UNITED STATES PATENT AND TRADEMARK OFFICE

APPLICATION NO.	FILING DATE	FIRST NAMED INVENTOR	ATTORNEY DOCKET NO.	CONFIRMATION NO.
10/773,797	02/05/2004	Felice DiMascio	HAT-0020-P	8450
23413 7590 10/10/2008 CANTOR COLBURN, LLP 20 Church Street 22nd Floor Hartford, CT 06103				
EXAMINER				
WILKINS III, HARRY D				
ART UNIT		PAPER NUMBER		
1795				
NOTIFICATION DATE		DELIVERY MODE		
10/10/2008		ELECTRONIC

Office Action Summary

DETAILED ACTION

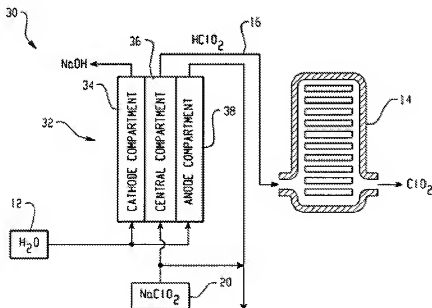
6. Claims 27-37 are rejected under 35 U.S.C. 112, first paragraph, as failing to comply with the written description requirement. The claim(s) contains subject matter which was not described in the specification in such a way as to reasonably convey to one skilled in the relevant art that the inventor(s), at the time the application was filed, had possession of the claimed invention. While Applicant shows that support in the specification as filed for feeding the effluent from the anode compartment into the alkali metal chlorite solution as shown in figure 2 and described at paragraph 71 of the specification, Applicant has not shown the entire scope of the alkali metal chlorite solution being in "fluid communication" with an effluent produced in the anode compartment. This claim language also covers an instance where a portion of the alkali metal chlorite solution was branched off and mixed with the effluent from the anode compartment to create another process stream, such as shown by:

Thus, Applicant has failed to show possession of the full scope of claim 27 at the time of invention. It is suggested that the claim language be amended to clarify that the effluent from the anode compartment is used to dilute the incoming alkali metal chlorite solution and/or to clarify that the effluent from the anode compartment otherwise flows into the alkali metal chlorite solution rather than the other way around. This would distinguish the claimed invention from the possibility shown above and be commensurate in scope with the disclosure as filed.
